SUBJECT: Forwards Rev 26 to "QA Program for Station Operation," in accordance with 10CFR50.54(a)(3). Rev 26 incorporates organization related changes associated with reorganization of Nuclear Operations Group & clarification of methods.

SUBJECT: Revised Submittal of Quality Assurance Program for  
Station Operation  
R. E. Ginna Nuclear Power Plant  
Docket Number 50-244

Quality Assurance Program for Station Operation

Revision 26

FIGURE 17.1.2-1  
Organizational Chart

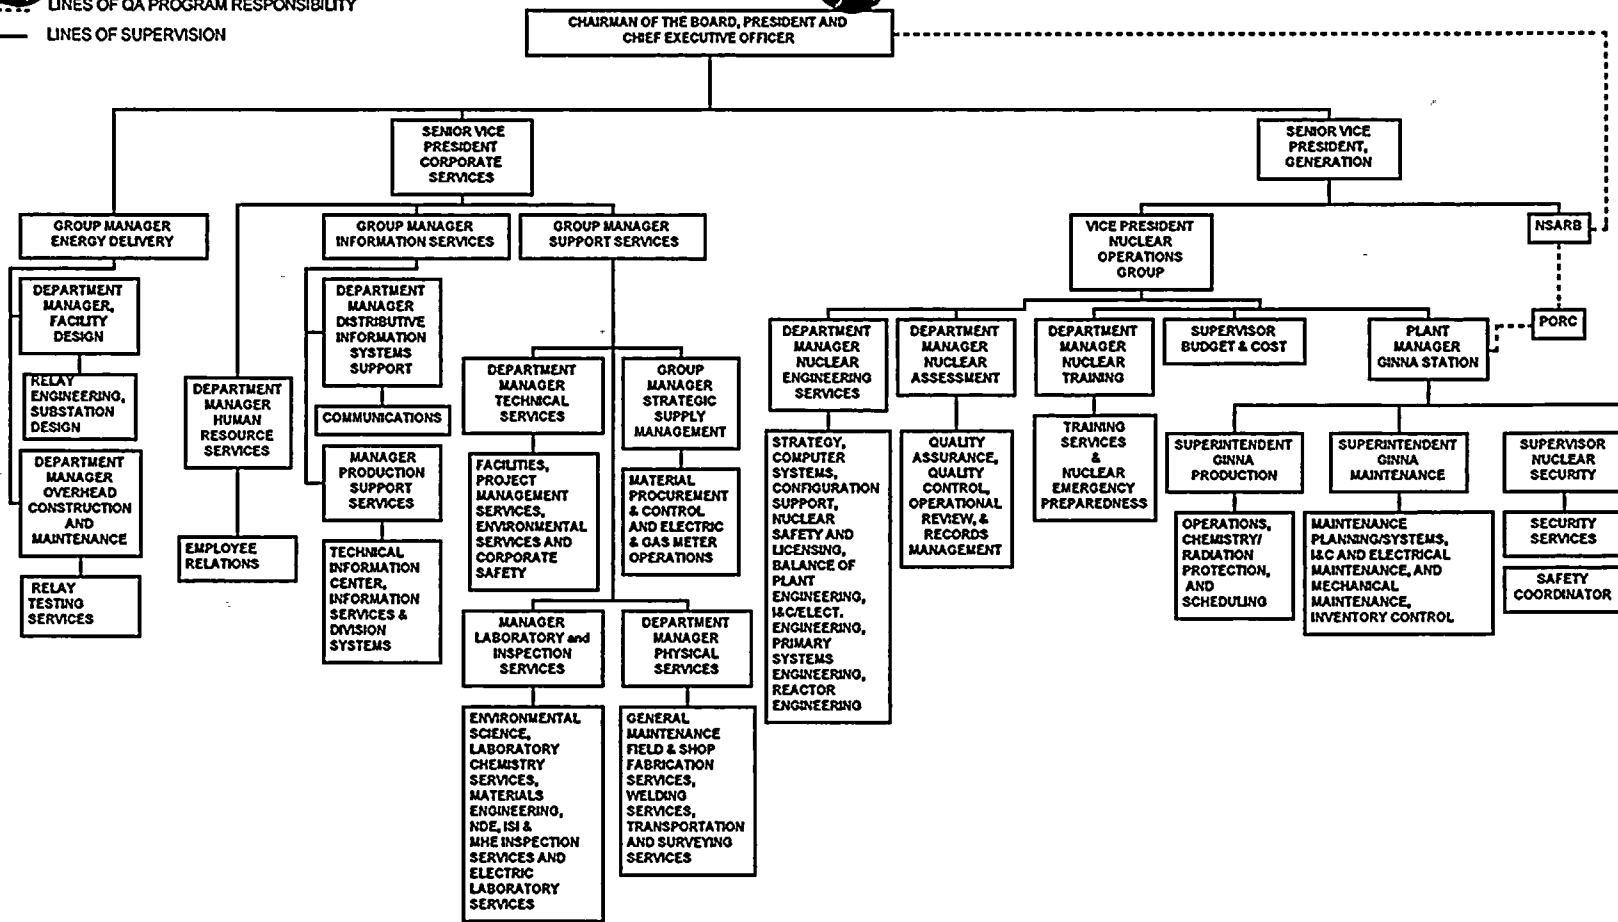
The following organization changes were made and are reflected throughout the text of the document and on the Figure 17.1.2-1 Organization Chart:

- The Department Manager, Nuclear Training now reports to the Vice President, Nuclear Operations Group. Additionally, the responsibility for Nuclear Emergency Preparedness was transferred from the Department Manager, Nuclear Assessment to the Department Manager, Nuclear Training.
- The positions of Director, Operating Experience and Manager, Nuclear Assurance have been eliminated. The responsibilities for these positions have been assumed by the newly created position of Manager, Operational Review.
- The responsibility for the fire protection program has been transferred from the Department Manager, Nuclear Engineering Services to the Plant Manager, Ginna Station.
- Nuclear Engineering Services reorganized internally. This change affected the Figure 17.1.2-1 Organization Chart only.
